RE: 160628 BYLONG COAL PROJECT FORESTRY NSW SUPPLEMENTARY RTS

PROPOSED BYLONG COAL PROJECT – FURTHER EPA COMMENT

Bylong Coal Project Response to Submissions on Groundwater

Project number G1606G
Document title Bylong Coal Project – Response to Supplementary Submissions on Groundwater
Site address Bylong, NSW
File name G1606.Response_to_Submissions_Final.docx

Figure 1
Predicted Groundwater Inflow/Seepage into Mining Areas

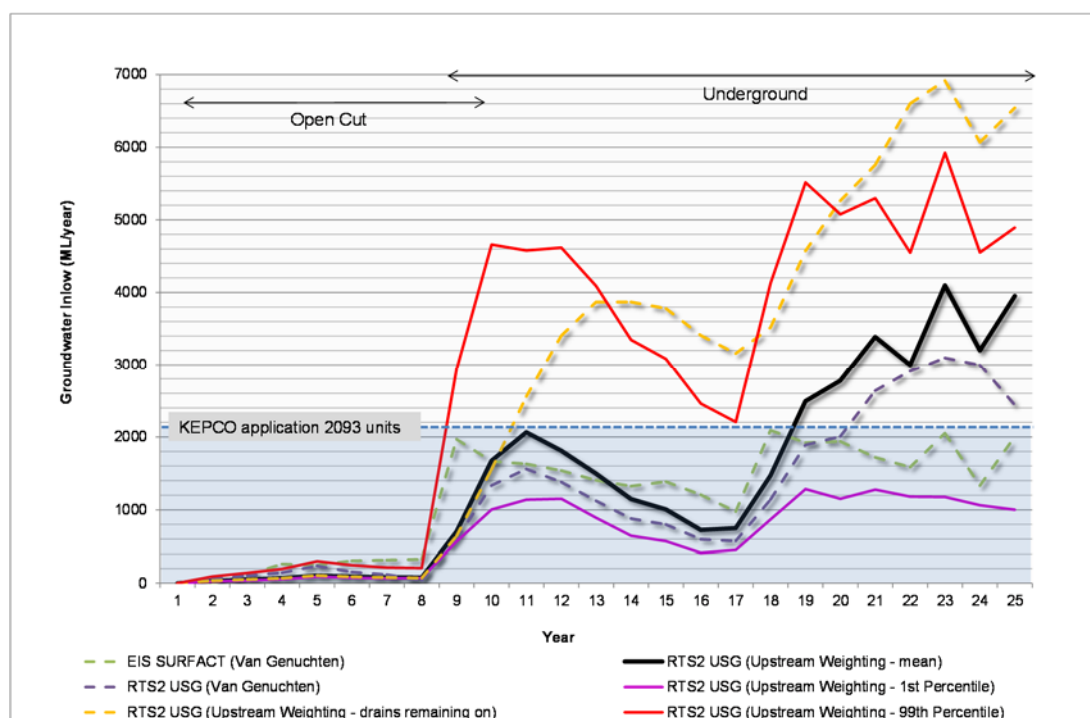
The proponent may not have correctly apportioned relevant take from each water source resulting from inflows to the mine, and may have underestimated the shares required in the Bylong River Water Source. The proponent holds 2535 shares in the Bylong River Water Source. It is understood that these shares will contribute to accounting for take of water from the bore field and take of water for agricultural purposes. However these shares will also need to account for passive take of water via alluvial loss and reduction in baseflow. For example the additional information received indicates that peak baseflow loss will occur in year 9 at 2.7 ML/day or 986 ML/year in the 99th percentile scenario. As such in that year this volume of water may not be actively extracted from the Bylong River Water Source and this should be reflected in the site water balance.

Figure 1 shows the various scenarios predicted by the numerical model in relation to the water licence application for 2,093 ML. It highlights for the base case (RTS2 USG (Upstream weighting – mean)), the mine can operate until Project Year 19 without needing to obtain additional water license units. It is also noted that the groundwater model predictions will be able to be further validated and refined with real data throughout the initial years of mining operations. This process will improve the predictions for the later years of mining within the underground mining area and assist in confirming the maximum water access licence requirements under the North Coast WSP.

Figure 3
Predicted Water Take (99th Percentile Scenario) from the Bylong River Water Source

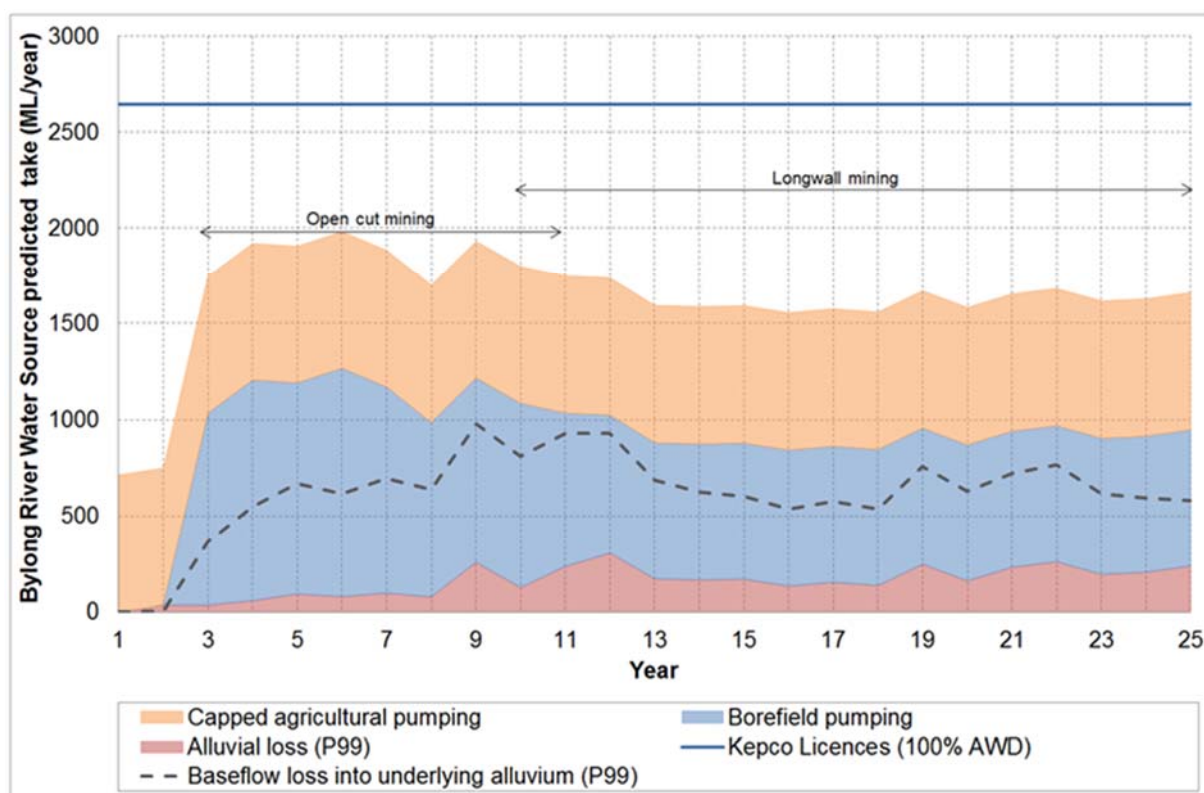
The proponent should investigate alternative sources of water supply for the scenario whereby insufficient shares in the Bylong River Water Source are held or alluvial aquifer depressurisation decreases the yield of the water supply from the bore field. This should be considered to ensure security of water for agricultural purposes and also to source water should make-good provisions be triggered.

Therefore, even if the predicted 99th percentile baseflow and alluvial losses were included within the water accounting, the Project would still have enough entitlement (at 100% Available Water Determination (AWD)) to account for the water taken, as illustrated in **Figure 3**.
